TENNESSEE VALLEY AUTHORITY BROWNS FERRY NUCLEAR PLANT

Steam Dryer RAI 15 Status

January 25, 2008

Browns Ferry Unit 1 Finite Element Model

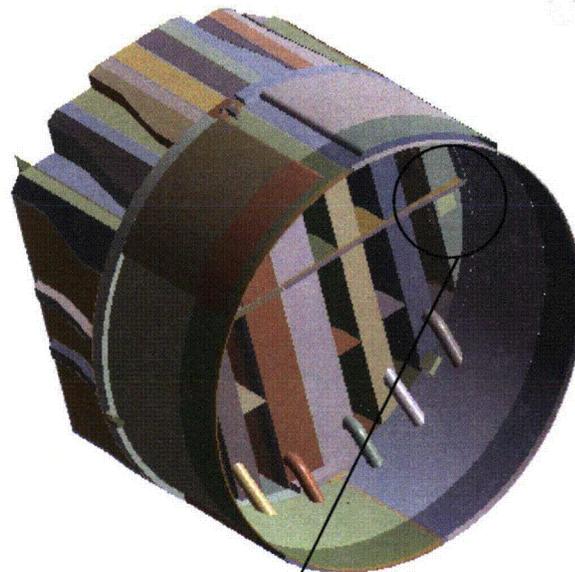
- Differences Between Unit 1 FEM and Actual Configuration
 - Cover Plate is 1” thick vs. ½” thick as modeled
 - Cover plate has no man-way as modeled
 - Outer hood vertical stiffeners have top covers that were omitted in model
 - Dryer support restraint was modeled as bolted restraint – now revised to pin connection
 - Support beam was disconnected from support ring (due to cracked welds) vs. modeled as attached to support ring

Increase cover plate thickness to 1"
Analyze with a 3/4" Fillet weld
Remove Man way
Revise Dryer support restraint
Add top covers to vertical stiffeners

Browns Ferry Unit 2, 3 Finite Element Model

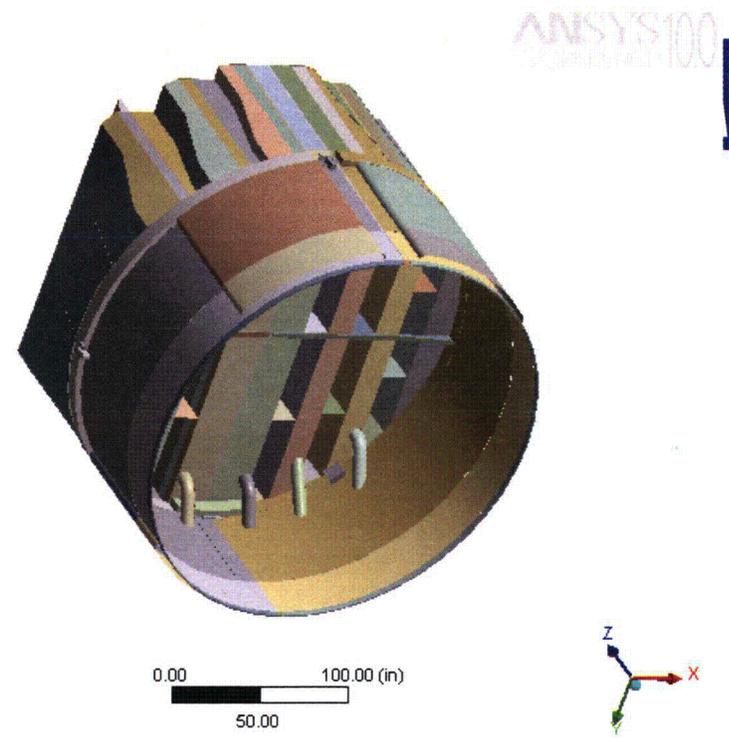
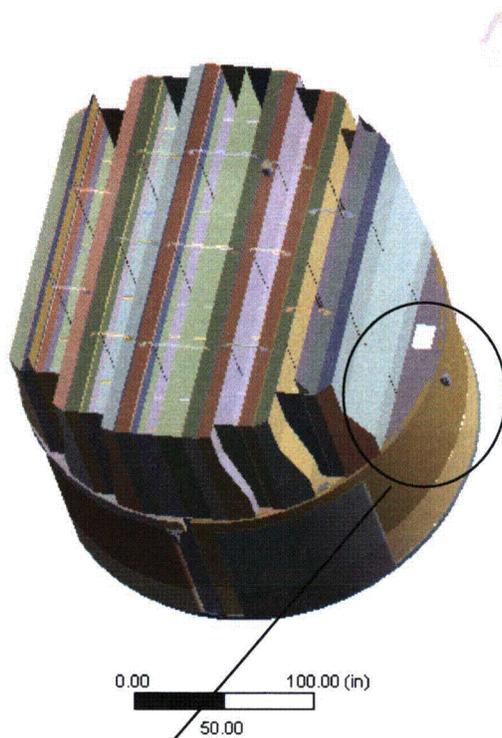
- Differences Between Unit 2/3 FEM and Actual Configuration
 - The cover plate attachment welds to support ring and hood were not described as undersized welds in stress analysis
 - The man-way attachment welds were not described as undersized welds in stress analysis
 - The cover plate was not modeled with a 2" rise to the hood attachment
- Modifications to Unit 2 Steam Dryer in 2009
 - Replace and upgrade dryer tie bar design
 - Reinforce cover plate and man-way welds
- Modifications to Unit 3 Steam Dryer in 2010
 - Replace and upgrade dryer tie bar design
 - Reinforce cover plate and man-way welds
- FEM Verified

- Clarify that Cover Plate & Man-way welds to be reinforced from 1/4" to 3/8"
- Cover plate slopes up 2" from support ring, was modeled as flat
- Revise Dryer Support Restraint from fixed to pinned
